I have run across some modeling inconsistencies between the 2013 and 2014 posted short circuit cases.

Attached are screenshot examples, the differences range from bus number changes from ERCOTs 160XXX range to AEPs 80XXX range, the number of generators at the site, the amount of generation of a particular site, GSU impedance values changing, generator source impedance changing, and current limiting of generators changing among other discrepancies.

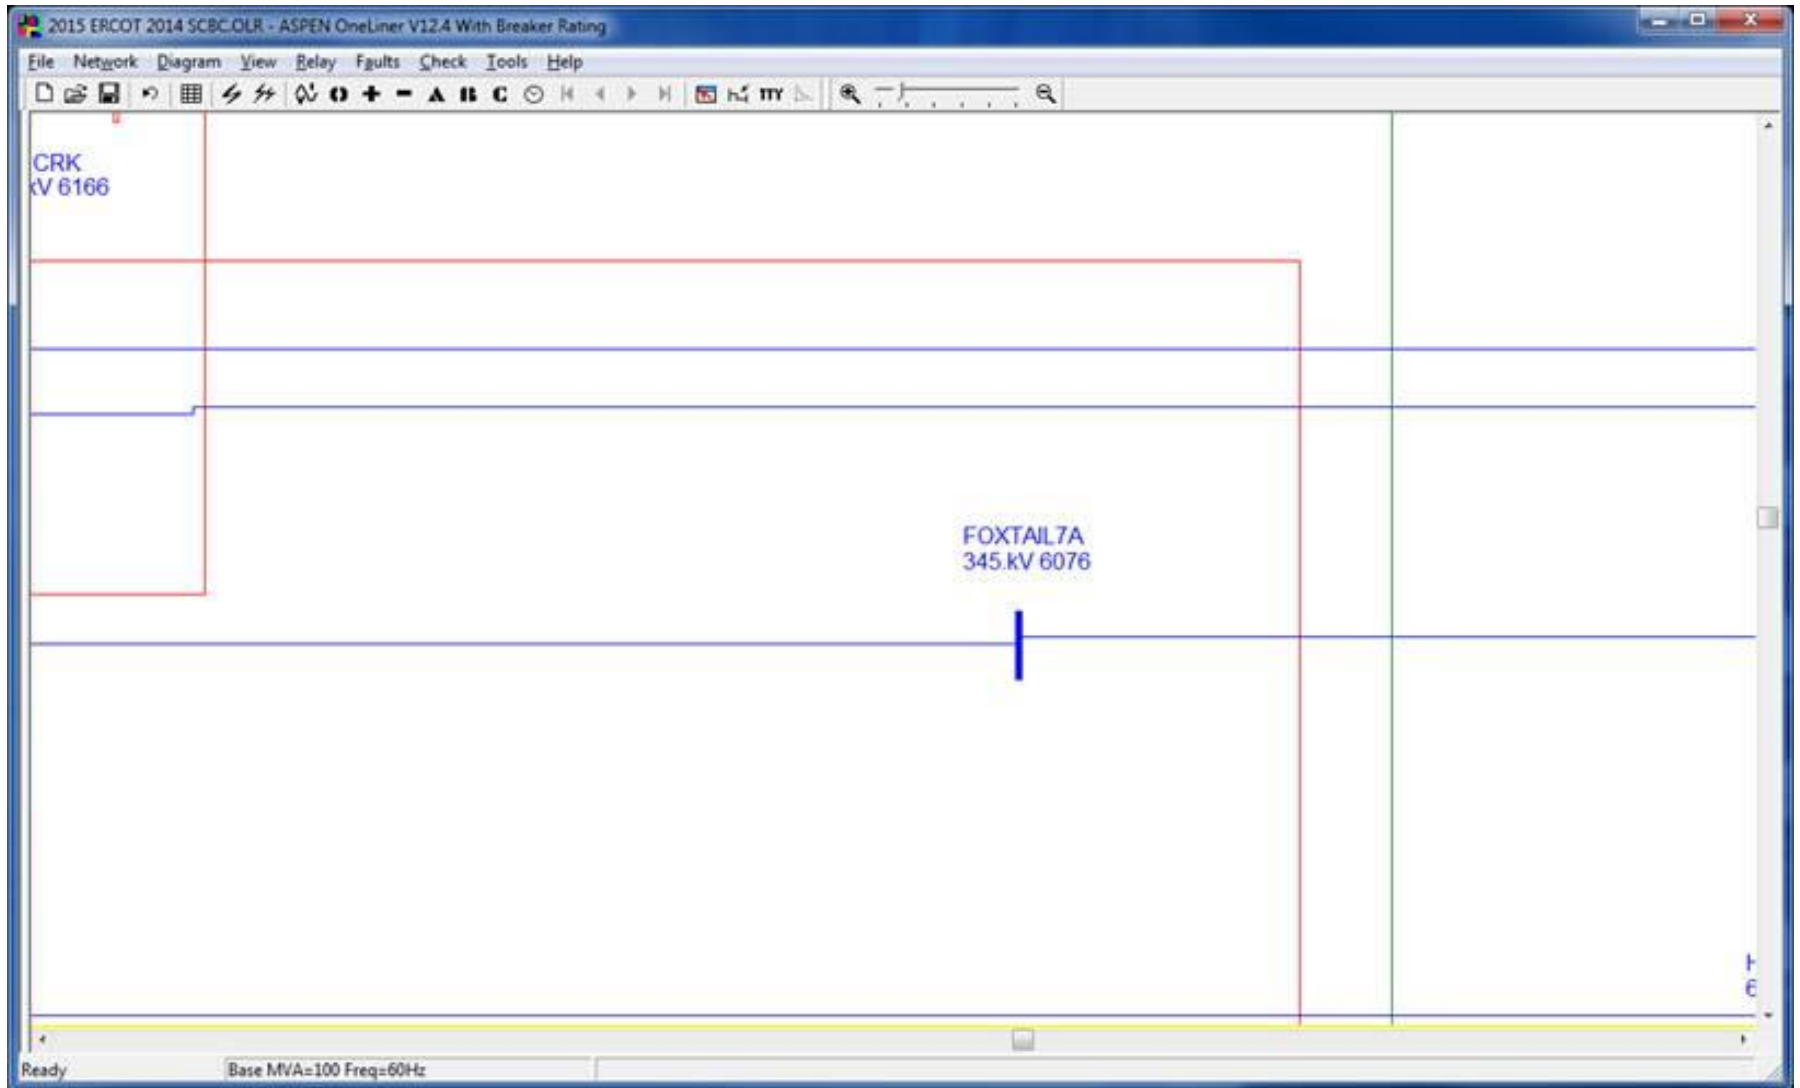
Papalote and Cotton wind farms this is the incorrect model as to total number of farms

Comment: This is how the 2014CY model looks.

Same issues with Papalote

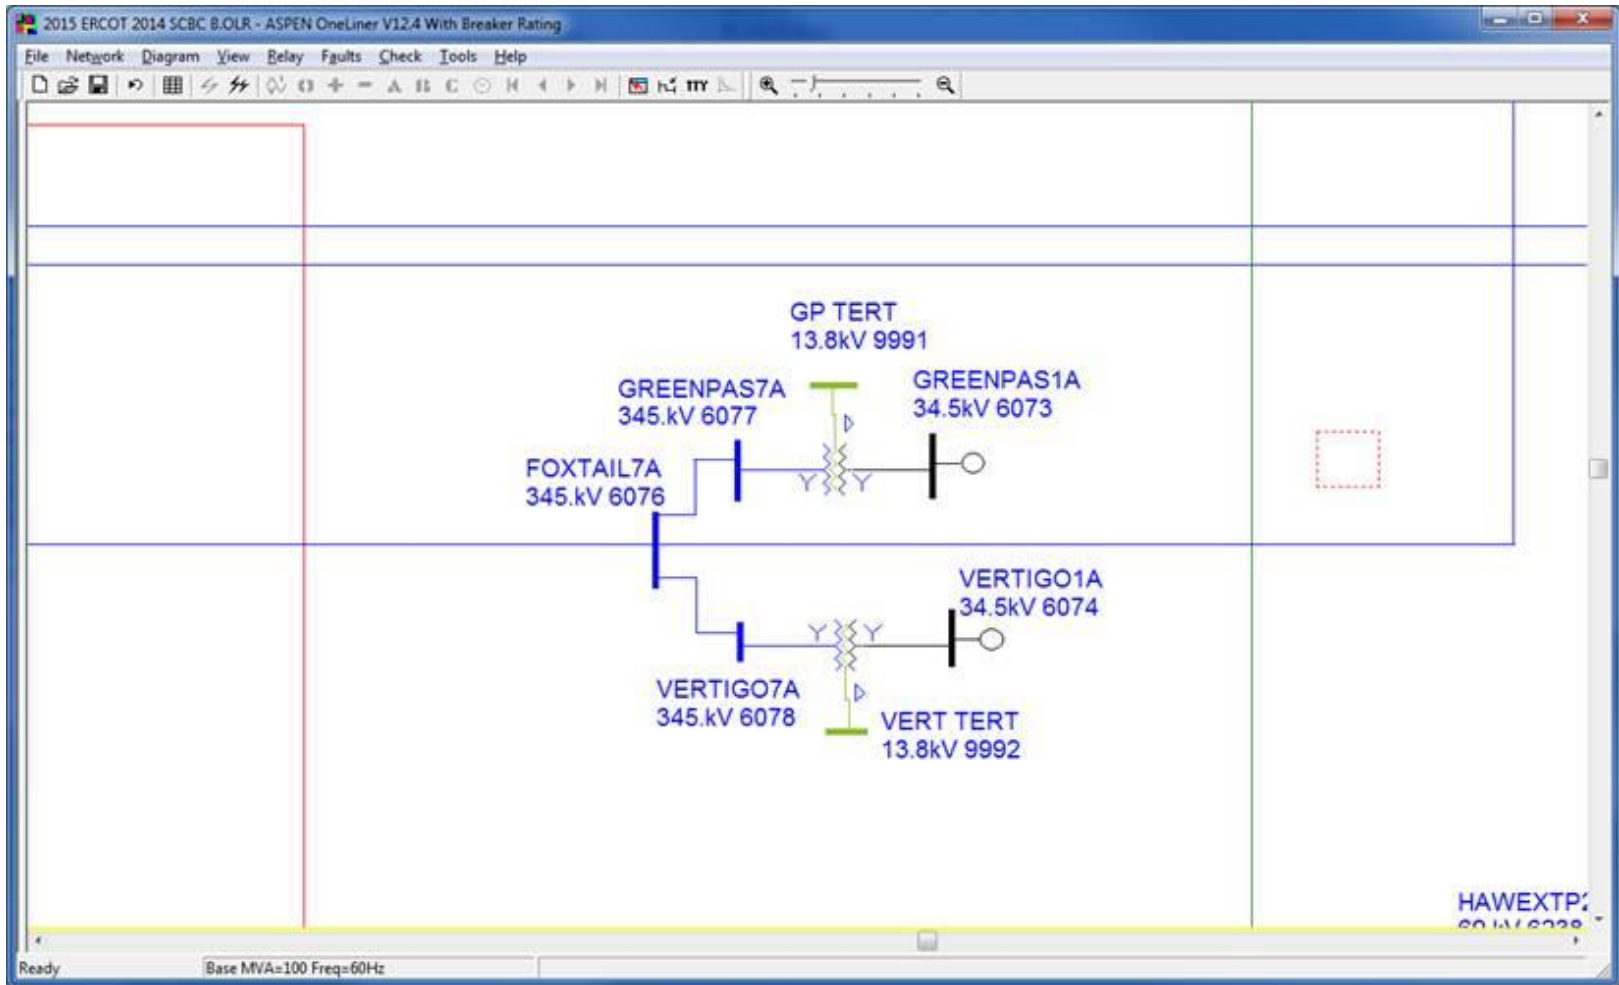
IA was signed for a wind farm off of Foxtail bus 6076 but none modeled in the cases

I added the wind farms into my internal case because it is going online about Dec 1, 2014 and we had to get relay settings done.

Comment: This would be in the 2015+ FY cases, and not 2014CY, right?
